Amendment Report

Coleambally Battery Energy Storage System

July 2023

Project Number: 22-522

Coleambally BESS Indicative layout

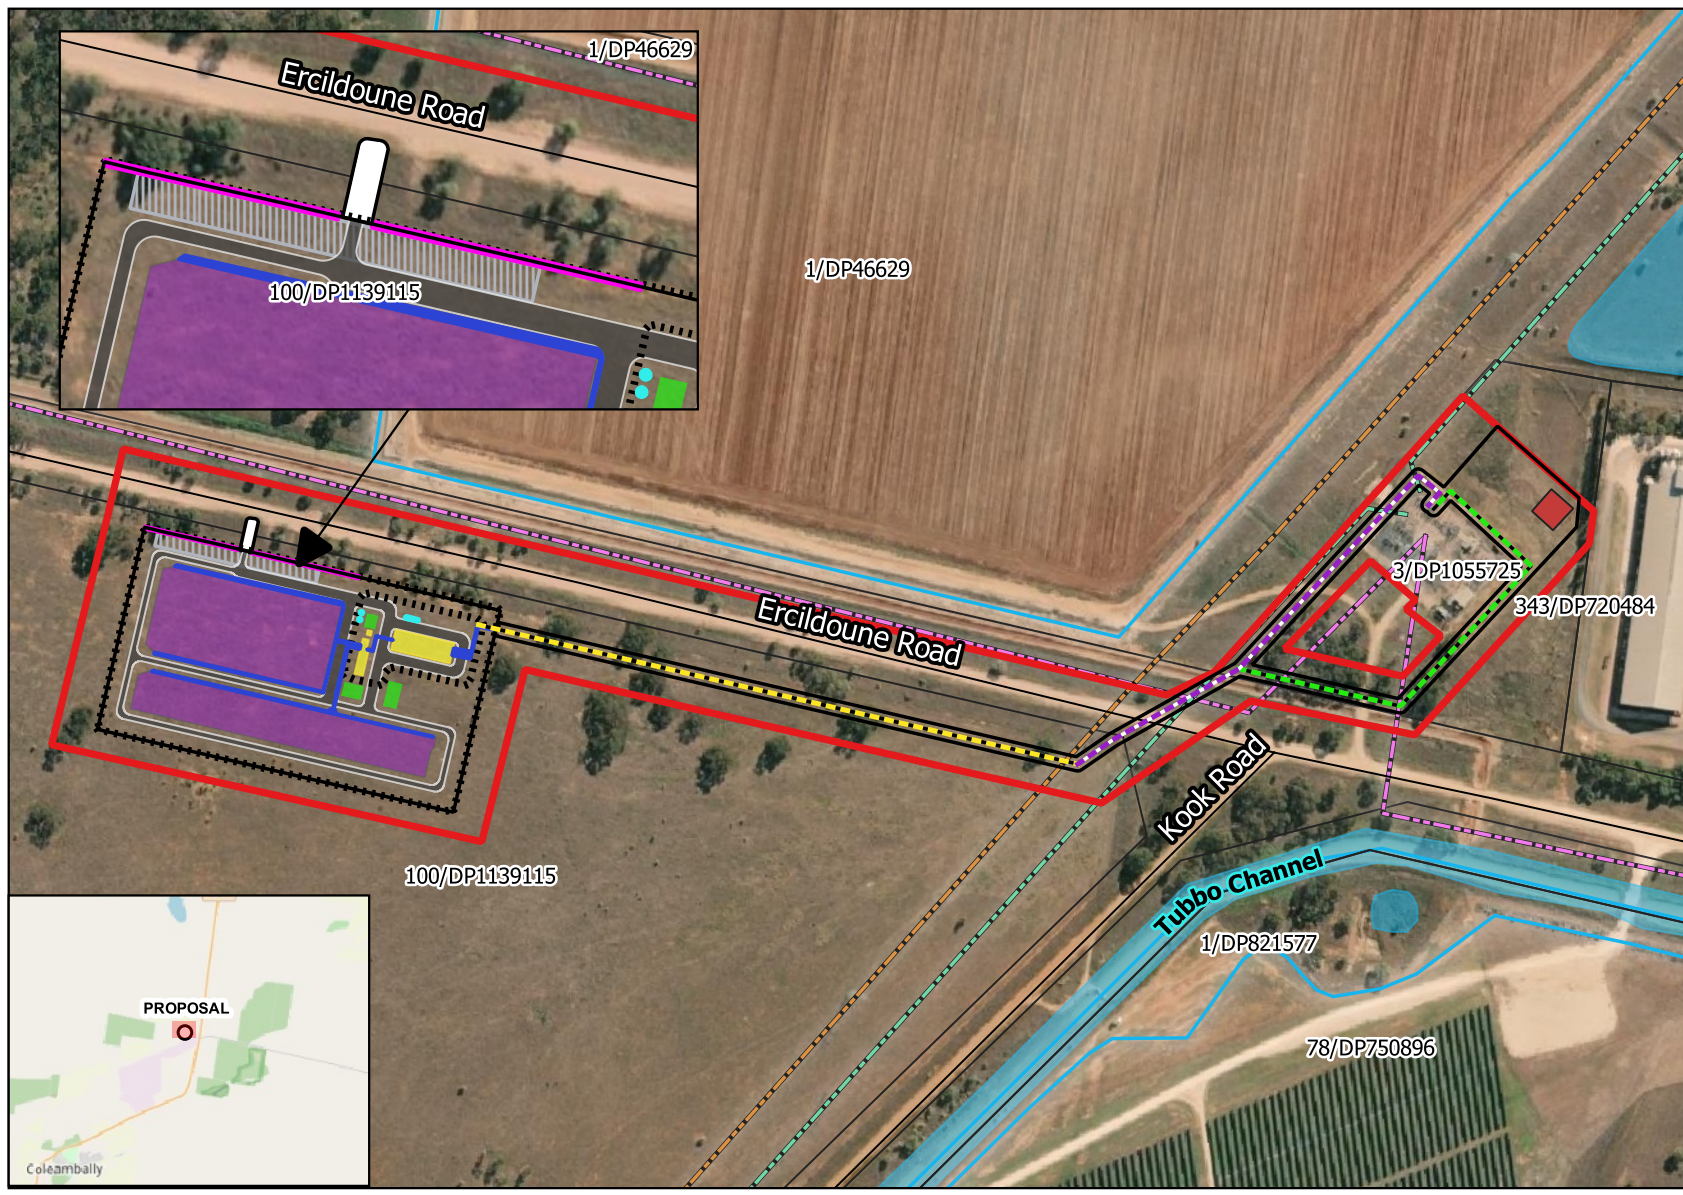
- A new control room and associated underground cabling
- Extension of the substation bench to accommodate a new connection bay within the TransGrid substation lot, as requested by Lumea
- Amend commitments around providing a Community Benefit Scheme (CBS) and replacing with voluntary payments to meet the requirements of the Council Section 7.12 Development Contributions Plan.

Refer to Table 1-1 for a comparison of amendments to the Project. Figure 1-1 shows the amended layout of the proposal.

Figure 2-1 Updated development site and footprint after amendments

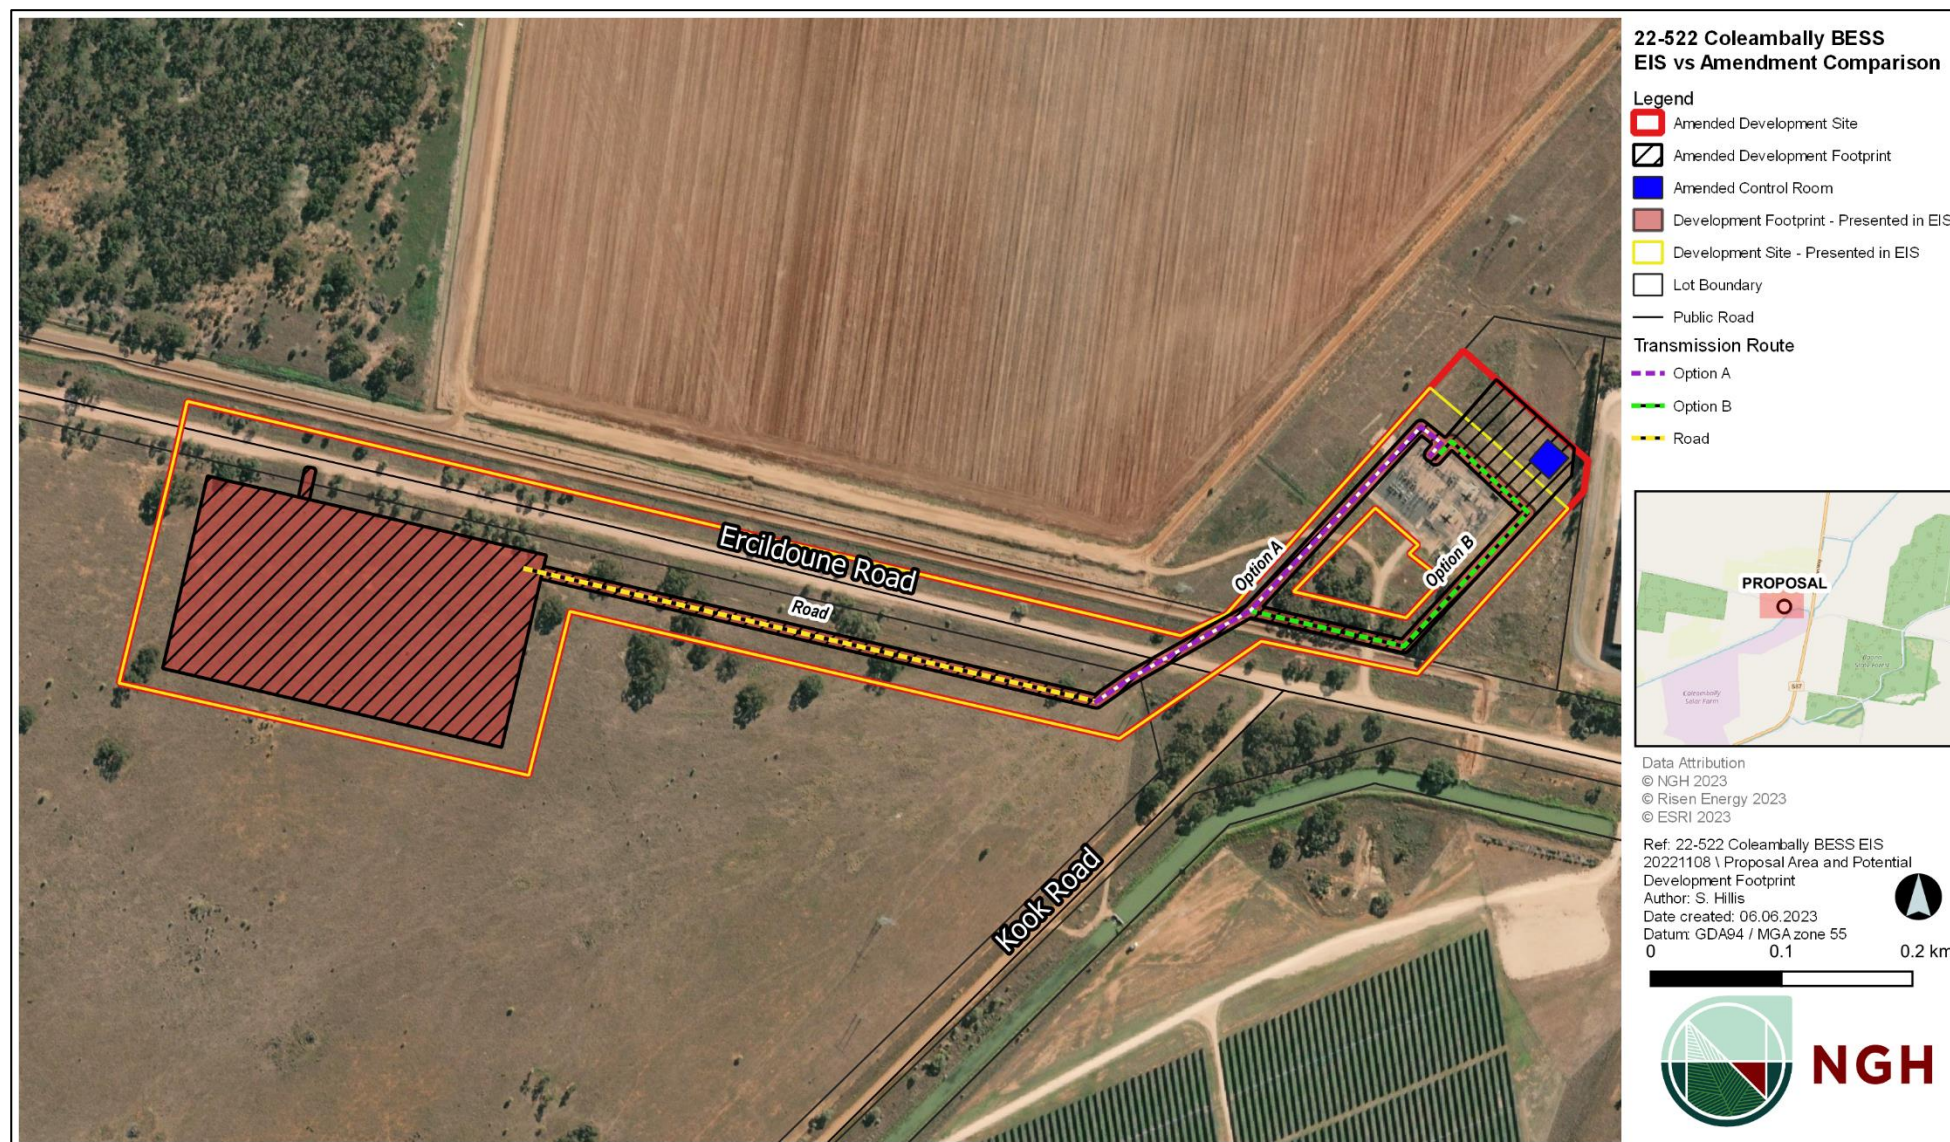
The disturbance footprint of the Coleambally substation would be increased from 5.18ha to 5.67ha. This increase to the northern boundary of the previous footprint would allow ample room to construct and safely operate the switch bay and control room. The updated area in comparison to the old area is shown in Figure 2-1.

The Project proposes to extend the development footprint to the north/northeast of the project, extending about 53m to the north/northeast of previously proposed works as shown in Figure 2-1. The amendment would take the development footprint 9m closer to receiver R13, which is a Community centre, reducing the separation distance from 2542m to 2533m, which would not have any significant impact in relation to noise and vibration impacts.

Figure 1 Desktop review of the additional substation extension area and the new control room building which were determined to be entirely within the area which was previously subject to archaeological survey for this project.

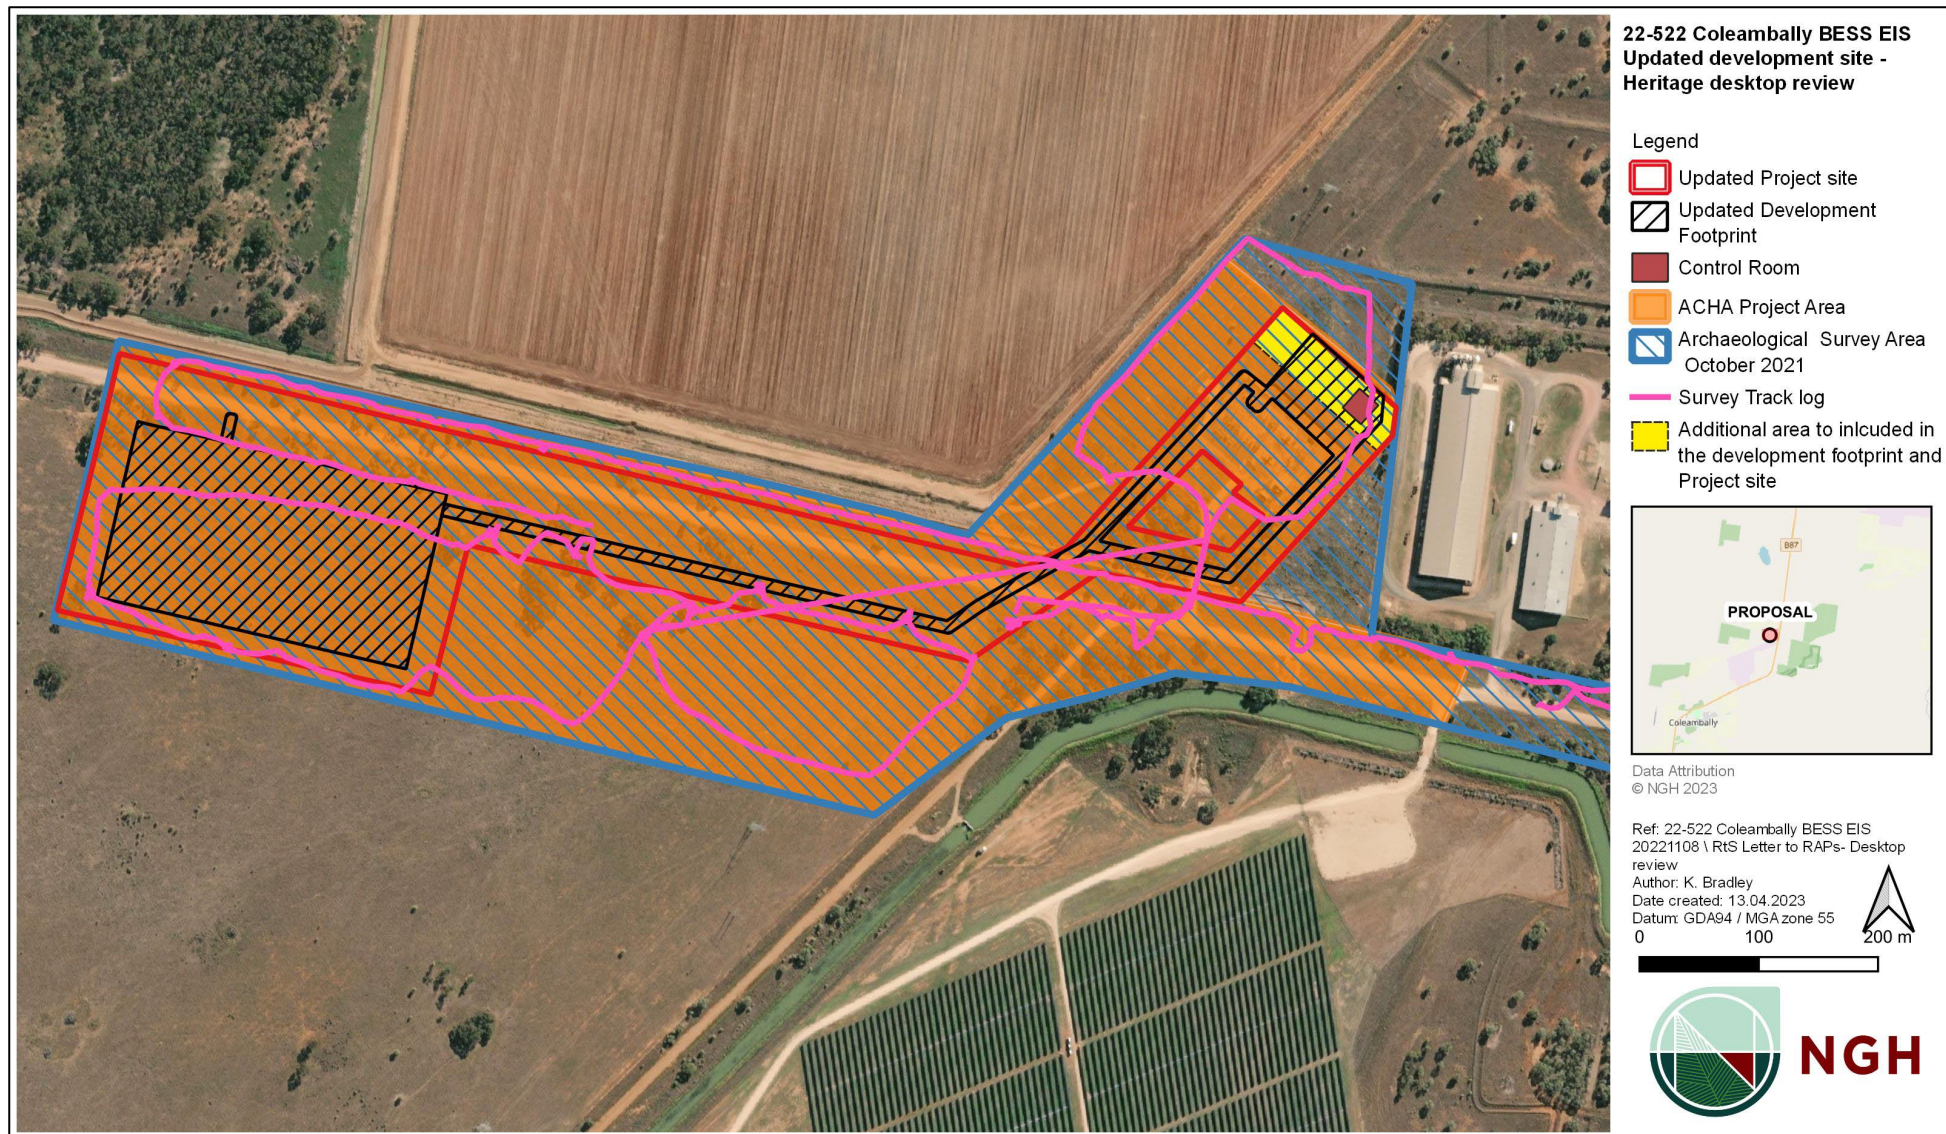
As part of a desktop review, it has been determined by a qualified archaeologist (NGH Principal Heritage Consultant Kirsten Bradley) that the additional substation extension area and the new control room building are entirely within the area which was subject to archaeological survey for this project in October 2021. This area was surveyed in October 2021 by an NGH archaeologist with two Aboriginal community representatives (see Figure 1) with no Aboriginal objects, sites or areas of potential archaeological deposits (PAD) recorded. Therefore, it has been determined by NGH that the additional area which will be incorporated into development site and development footprint (see Figure 1 and Figure 2 below) has been sufficiently surveyed and assessed for Aboriginal objects, and that this minor change to the mapping of the development site and development footprint (which also includes the area for the new control room building) will not change or modify the impact assessment, mitigation measures or the recommendations noted in the ACHA (version Final 2.0 dated 18/11/2022) for this project.

Figure 2 Aboriginal sites and the revised development site and development footprint area.

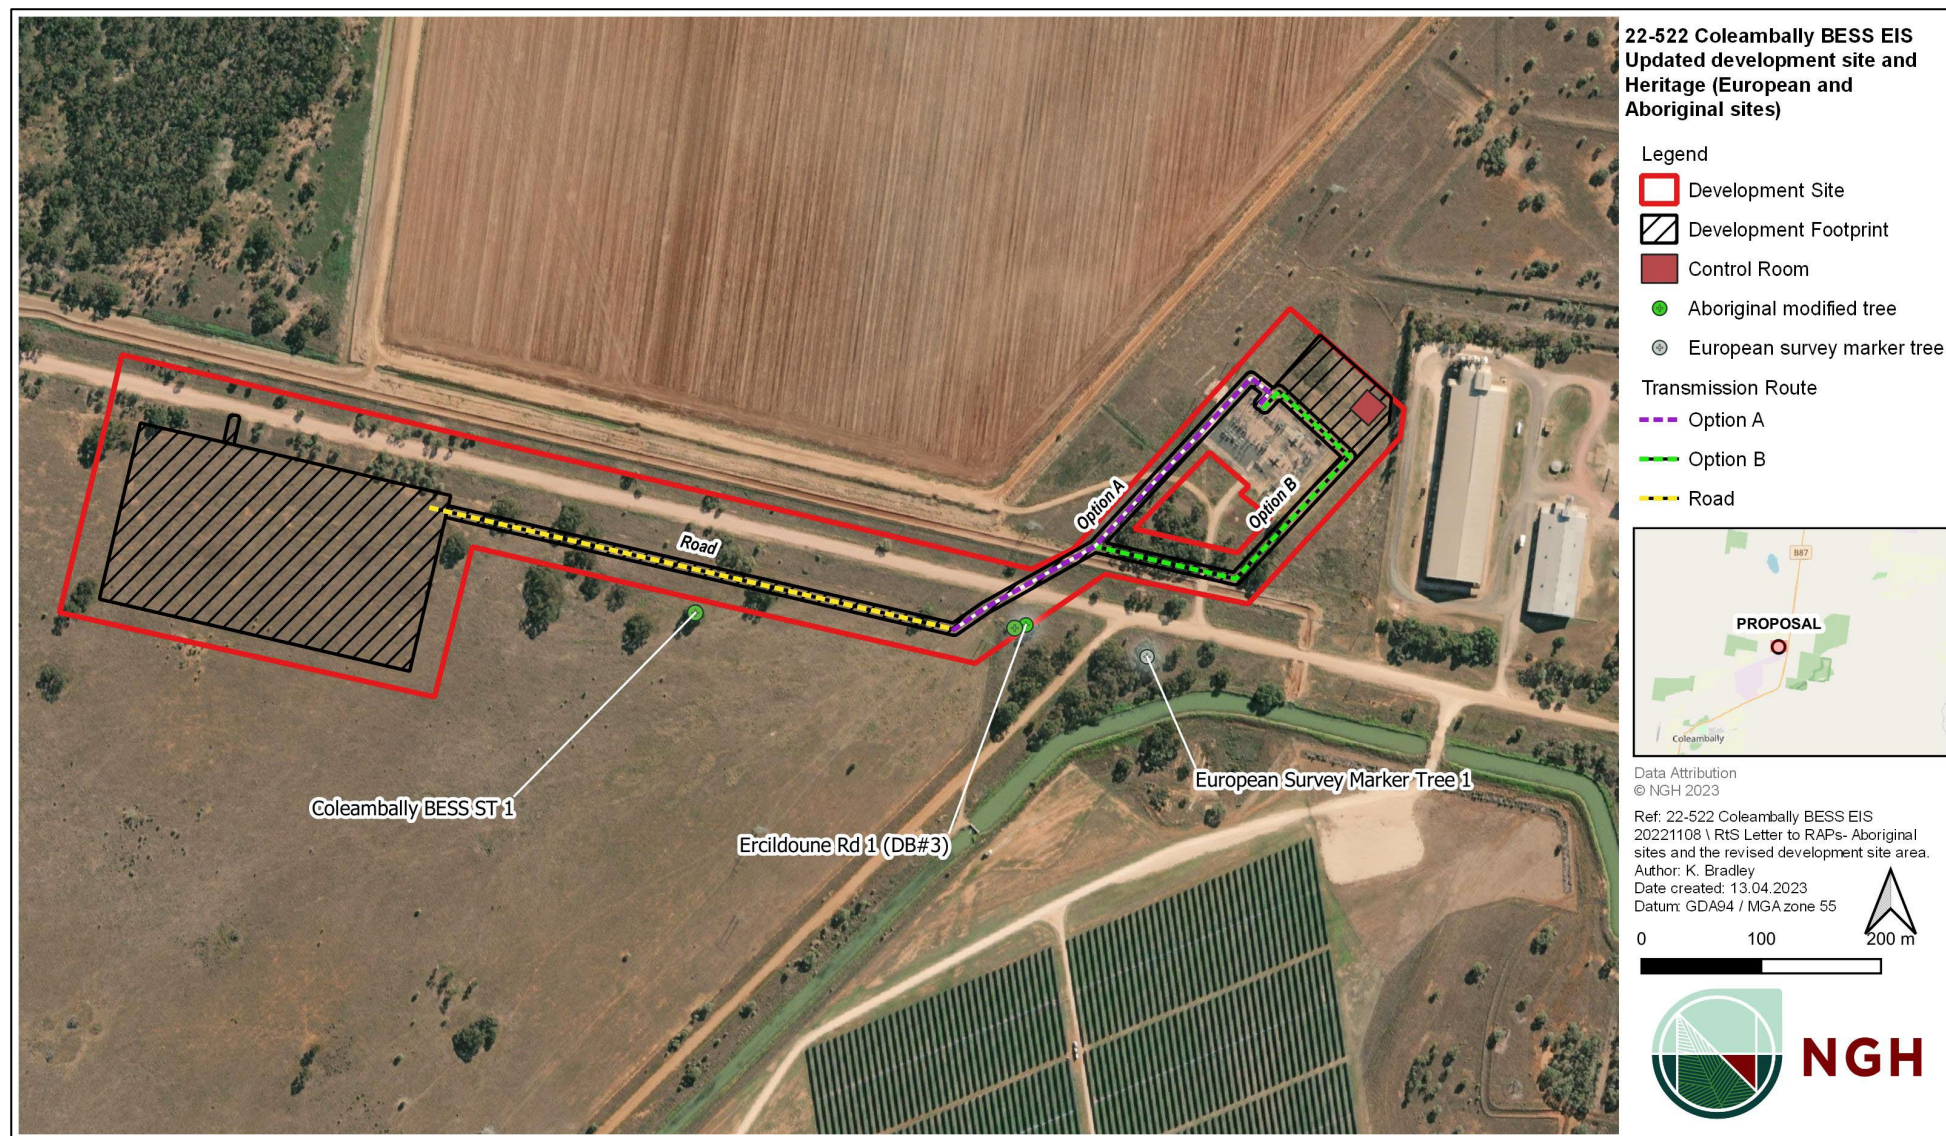
To address these requirements, a minor change to the mapped area for the development site and development footprint for this project is required (the additional development site area is approximately 140 x 40 metres) and therefore any new impacts to Aboriginal Heritage are required to be considered and assessed.

Figure 2 has been provided to clearly show you the revised development site, revised development footprint and new control room building location compared to the two known Aboriginal sites (Coleambally BESS ST1 and Ercildoune Rd 1) and the European survey marker tree as noted in the ACHA (version Final 2.0 dated 18/11/2022) for this project.

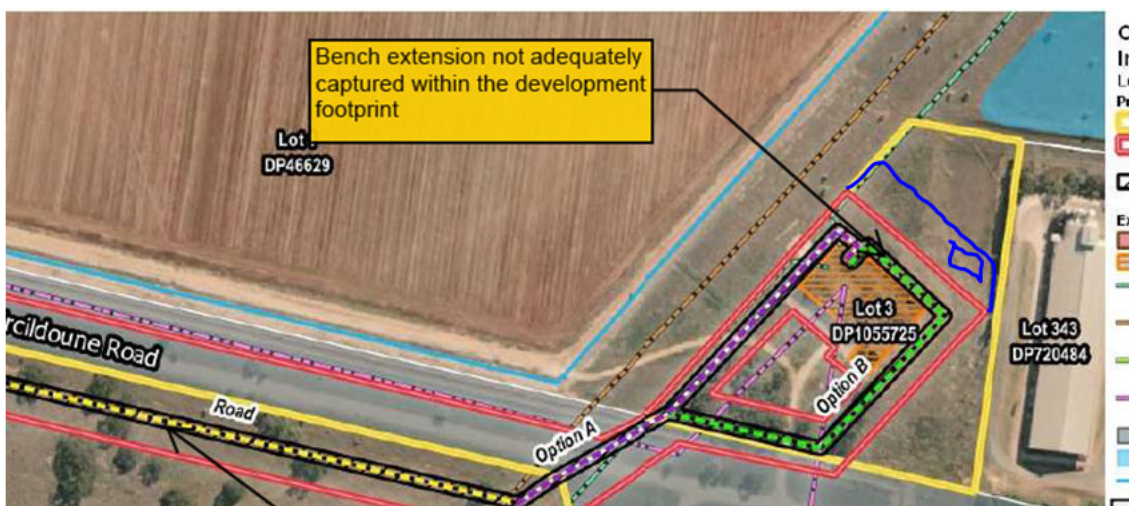
I have roughly sketched (not to scale) the additional 10m on the Northern side of the Coleambally substation, I have also shown the location of the new Control room building, also to be located on the Northern end within the 20m area outside the existing edge of the Coleambally substation. The building is nominally sized at 13m long x 3m wide. The intention is to remain within the Yellow Boundary/Essential Energy land area, so I hope my sketch is ok. In Section 3.2.3 of the EIS, please include the detail of the works required at Coleambally substation to include the extension of the substation bench to accommodate the connection bay, and underground cable as well as a new Control room building.
